# Access Compliance Report

## Public Rights-of-Way

Intersection ID: 44463	Main Street: BUCKHORN_ST	Cross Street: VALCOURT_RD	Location: SE
ADA ID: E2D7CCCEDE6F	Ramp Type: PerpDiag	Initial Pass/Fail: Fail	Overall Compliance: No
Codes/Mitigation Info/Possible Solution			Severity Score: 10
			Field Measurements/Component Compliance

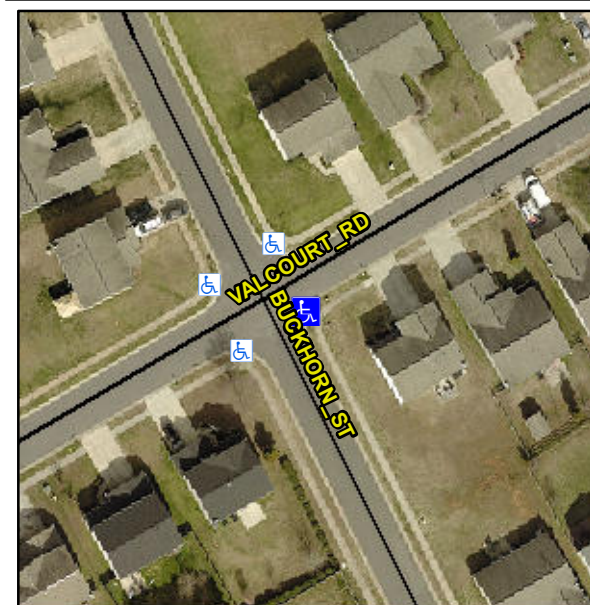
**Not Found, R304.5.1, R304.5.3**

Compliance	Description	Data	Compliance	Description	Data
N/A	Ramp Length (in)	49.0	Yes	Ramp Slope (%)	5.0
No	Ramp Width (in)	37.0	No	Ramp XSlope (%)	2.9
N/A	Flare Type LT	N/A	N/A	Flare Type RT	N/A
N/A	Flare Slope LT (%)	N/A	N/A	Flare Slope RT (%)	N/A
N/A	Flare Traversable LT?	N/A	N/A	Flare Traversable RT?	N/A
N/A	Landing Length (in)	N/A	N/A	DWS Provided?	N/A
N/A	Landing Width (in)	N/A	N/A	DWS Contrast?	N/A
N/A	Landing Slope (%)	N/A	N/A	DWS Length (in)	N/A
N/A	Landing X Slope (%)	N/A	N/A	DWS Full Width?	N/A
N/A	Landing Curb? (Y/N)	N/A	N/A	DWS Offset (in)	N/A
N/A	Shared Landing?	N/A			
N/A	Gutter Ponding?	N/A	N/A	Gutter Slope (%)	N/A
N/A	Gutter Lip Ht (in)	N/A	N/A	Gutter X Slope (%)	N/A
N/A	Painted X Walk1?	No	N/A	Painted X Walk2?	No
	X Walk 1 Direction	To N		X Walk 2 Direction	To W
N/A	X Walk 1 Width (in)	N/A	N/A	X Walk 2 Width (in)	N/A
	X Walk 1 Slope (%)	1.9		X Walk 2 Slope (%)	0.9
	X Walk 1 X Slope (%)	1.0		X Walk 2 X Slope (%)	2.6

**Remove & Replace Curb Ramp With Two New Directional Ramps or Equivalent.**
